The Los Alamos National Laboratory *Fieldwork Plan for R-22 Well Rehabilitation and Conversion* is Unacceptable and Must be Denied by the New Mexico Environment Department Report Version February 20, 2009

By Robert H. Gilkeson, Registered Geologist P.O. Box 670 Los Alamos, New Mexico 87544 rhgilkeson@aol.com 505-412-1930 And Joni Arends, Executive Director Concerned Citizens for Nuclear Safety 107 Cienega Street Santa Fe, New Mexico 87501 jarends@nuclearactive.org 505 986-1973

Figure 1. The locations of LANL characterization wells R-22 and R-23 east of the LANL 63-acre landfill and waste dump Area G/MDA G.

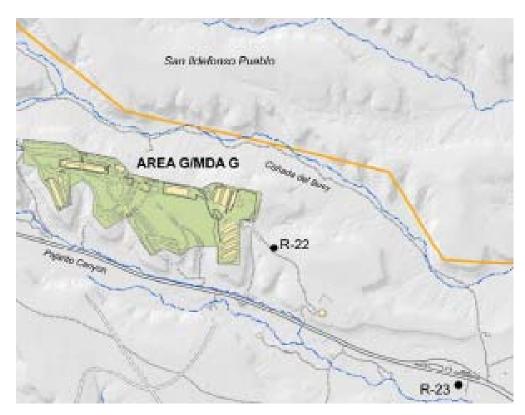
from the hazardous and mixed wastes buried in MDA G. Figure 1 shows the location of well R-22 approximately 500 feet east of the eastern boundary of MDA G/ Area G. MDA G/ Area G is the largest waste disposal site at LANL and occupies 63 acres. Burial of radioactive and mixed wastes in unlined trenches and shafts began in 1957 at MDA G and burial of low-level radioactive continues to the present time at Area G.

- The direction of groundwater flow at the water table below MDA G is from west to east toward the Rio Grande. The travel time for contaminated groundwater in the permeable aquifer strata below MDA G below MDA G to reach wells R-22 and R-23 is not known because of insufficient characterization of the geology below and away from MDA G.

- The many mistakes in the location, drilling, well construction, misplaced well screens and improper sampling methods prevent the wells R-22 and R-23 from producing reliable and representative water samples for the detection of groundwater contamination from MDA G.

Figure 2. The as-built construction of LANL characterization well R-22.

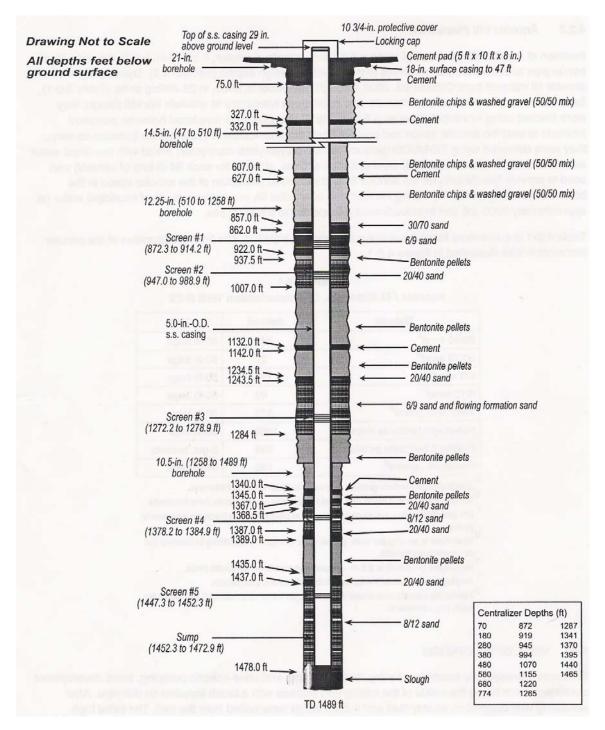
Figure 2 shows the as-built design of well R-22 with five well screens. Screen #1 is installed across the water table and screen #5 is installed at a depth of 560 feet below the water table. When the R-22 borehole was drilled in September of 2000, the top of the regional aquifer was at a depth of 883 feet below ground surface. The R-22 Plan will plug and abandon screens #4 and #5 and seal off screen #1. Jetting procedures will be used to redevelop screens #2 and #3. Then a pumping system will be installed in the well to produce water samples from screens #2 and #3. However, there are many factors that will prevent the rehabilitation of screens #2 and #3 from being successful. Those factors are described in the author's January 28, 2009 report and are summarized below. Well R-22 must be replaced because it does not meet the requirements of RCRA as a monitoring well but it is an important well for measurement of water levels.

Screen #2 in well R-22. The top of the 42-foot long screen is located 64 feet below the water table and in a basalt formation with a very low permeability of 0.04 feet per day (0.04 ft/day). The R-22 Plan makes the mistake to assume that screen #2 samples groundwater at the water table but the seven foot lower water level measured in screen #2 compared to screen #1 is evidence that there is little hydraulic communication between screen #2 and the water table. The available information shows that screen #2 is installed in a section of the basalt that only produces small quantities of groundwater. It is a requirement of RCRA 264 Subpart F and the NMED Consent Order to install monitoring wells in productive aquifers that are along the expected pathways for contaminated groundwater to travel from waste disposal sites. Screen #2 is installed in a confining bed that is not a pathway for groundwater contamination from MDA G.

- Screen #3. There are many factors that prevent screen #3 in well R-22 from being usable as a monitoring well to detect groundwater contamination from MDA G.

- The top of the 7-foot long well screen in located 390 feet below the water table and below thick layers of highly permeable aquifer strata that are not monitored by either screen #2 or #3.

The R-22 Plan does not describe the mistake during the construction of well R-22 that invaded the filter pack sediments surrounding screen #3 with the bentonite clay grout materials that were used to seal the well annulus. The bentonite clay has well known strong properties to prevent the detection and accurate measurement of many contaminants from MDA G.

Figure 3. Schematic of the pipe-based wire-wrap stainless steel well screen installed in many of the LANL characterization well R-22.

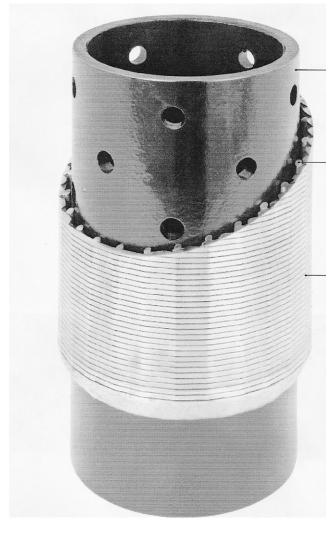
- The R-22 Plan does not recognize the LANL reports that show the well development performed in November of 2000 was not successful in removing the organic drilling additives or the bentonite clay grout from screen #3. The pipe-based design of the well screen is one factor that prevented the well development from being successful. The restrictive design of the pipe-based screen is displayed and described in Figure 3.

The R-22 Plan does not recognize that the restrictive design of the pipe-based well screen will also prevent the redevelopment activities in the R-22 Plan from being successful in cleaning the new reactive mineralogy and the grout contamination from screen #3.

- The restrictive design of the pipe-based screens prevented the original well development activities from removing the organic drilling additives from the five screened intervals in well R-22.

- The restrictive design of the pipe-based screens will prevent the rehabilitation activities in the R-22 PLAN from removing the new mineralogy created by the organic drilling additives and the bentonite clay grout contamination from screen #3 in well R-22.
